THE DIRECTOR
Industry Assessments, Planning and Assessment
Department of Planning, Industry and Environment

Subject Lake Macquarie Private Hospital Tower

Council staff have reviewed the application and provide the following comments:

Hughes Street

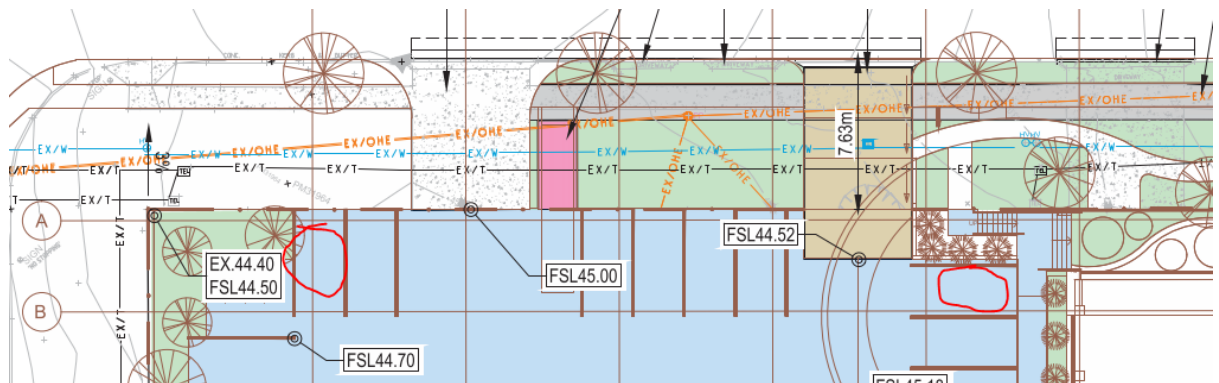
Upgrade footpath to 2.5m, in line with the upgrade on O'Brien Street to provide comfortable walkway for the high pedestrian traffic from the car park.

The parking spaces circled below do not comply with AS2890.1
